**RE: Colowyo Coal Company L.P.**  
**Permit No. C-1981-019**  
**Technical Revision 160 (TR-160)**  
**Adequacy Response**

## CHANGE SHEET FOR PERMIT REVISIONS, TECHNICAL REVISION, AND MINOR REVISIONS

Revision Description: **TR-160 Collom Haul Road Channels**

# **C-1, C-12, and C-13 Channel Configurations**

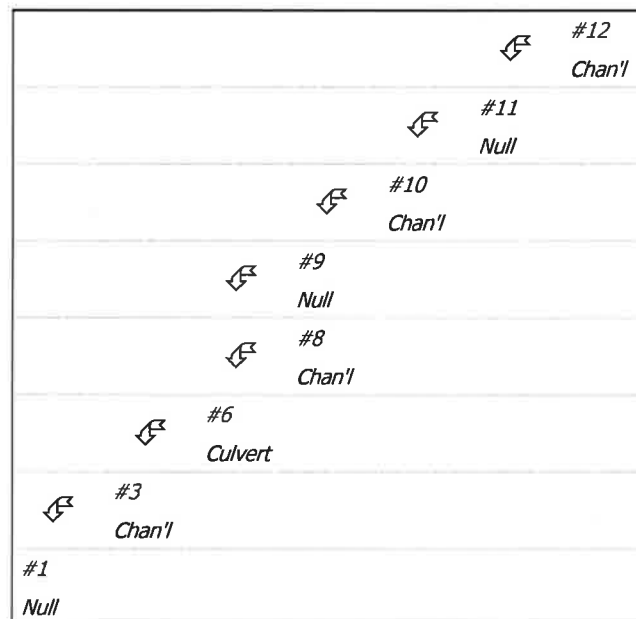
4. *When comparing proposed Exhibit 7, Item 25E hydrology demonstration for channels C-1, C-12 and C-13 with proposed Figure 7-25E-1, there appears to be an acreage discrepancy of 0.3 acres. This discrepancy appears to coincide with the immediate contributing acreage associated with the Collom Haul Road channel C-1, specifically the area of CN 85 designation. The total as shown in Figure 7-25E-1 has an acreage of 4.9 while the subwatershed hydrology details in Exhibit 7, Item 25E totals to 4.6 acres. For additional reference, please see the provided figure below this comment. Please provide and updated Exhibit 7, Item 25E hydrology demonstration and/or Figure 7-25E-1 with the correct acreage for Collom Haul Road channel C-1.*

**Response:** The 0.3-acre discrepancy was a typo in the SEDCAD™ model. The 1.1 acre (CN-85) subwatershed under structure #3 has been corrected to 1.4 acres (CN-85).
